Sumter City-County Planning Commission

June 22, 2016

MSP-16-16/HCPD-16-11 – 2607 Broad Street – Courtyard by Marriott (City)

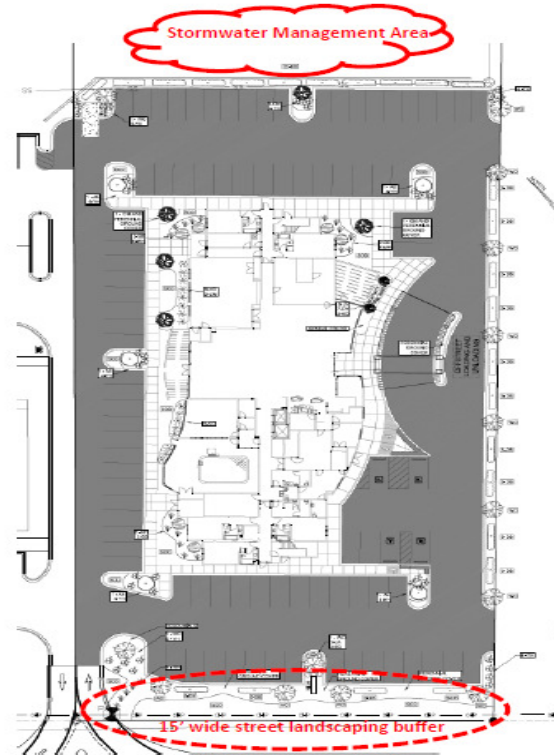
The submitted landscape plan is based upon the requirements of *Article 9* and makes accommodation for irrigated and mulched landscaping. Landscape buffers along the perimeter of the property and landscaping within the site meet or exceed minimum standards. The western perimeter of the site serves as a shared driveway. Therefore, a perimeter landscape buffer within this area is not achievable. However, the applicant agreed to increase the width of the street landscaping buffer from 10 ft. to 15 ft. in order to compensate for the lack of a western perimeter buffer. Staff finds this to be a reasonable proposal.

The majority of the project area of the site is barren. The existing treeline at the rear of the property, behind the existing stormwater management pond, will remain undisturbed.

Staff finds that the proposed landscape plan meets required standards.

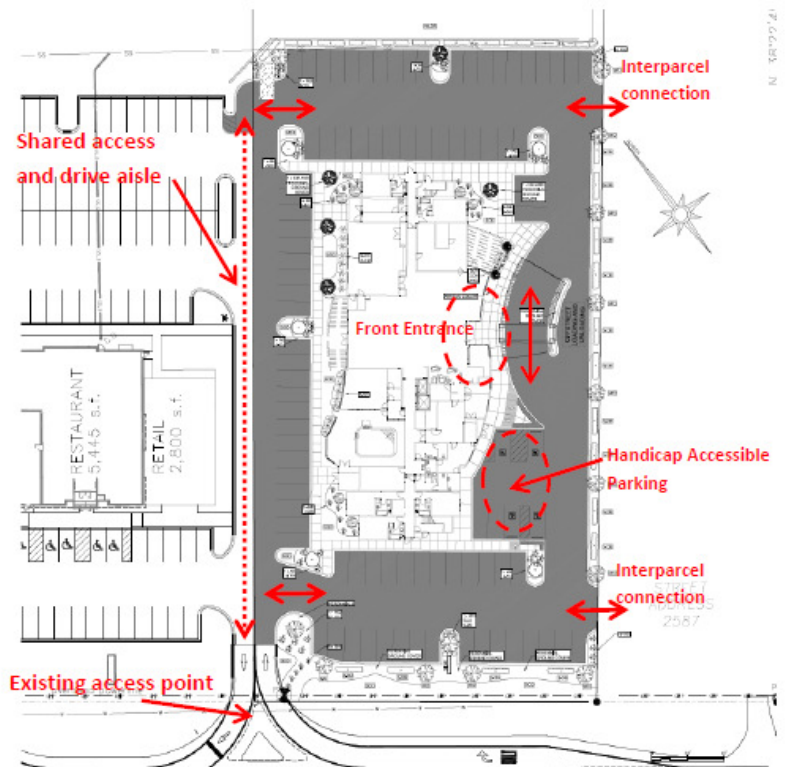
The existing right-in/right-out access was previously approved and developed when the Buffalo Wild Wings restaurant was built. The western part of the site is accessed via a shared drive aisle. From this drive aisle the parking lot is accessible from two western access points, one at the front, and one at the rear. Two eastern access points provide for the possibility of interparcel connections to the property to the east.

The main entrance to the hotel is located on the eastern side of the site and contains a covered entry as well as a loading/unloading space for deliveries.

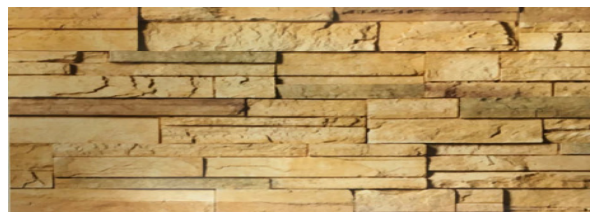
- a. If a new commercial building is proposed, not more than sixty percent (60%) of the facade facing a street may be glass or reflective materials;*

The proposed structure does not exceed the 60% threshold.

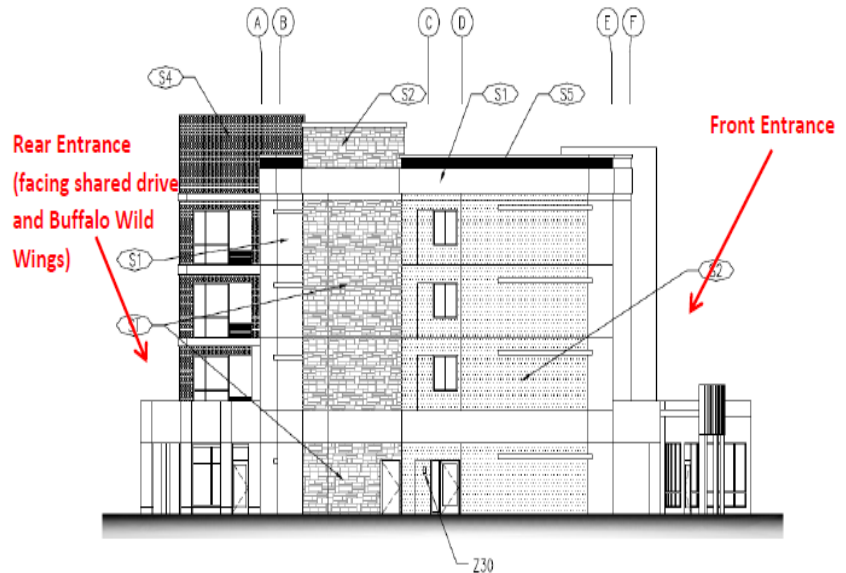
As shown in the illustration to the right, the side elevation of the hotel facing Broad Street incorporates multiple horizontal and vertical architectural relief elements in the facade. Additionally, a stack stone tower along with the proposed color scheme will enhance the aesthetic appearance. The north side of the hotel will be of similar appearance.
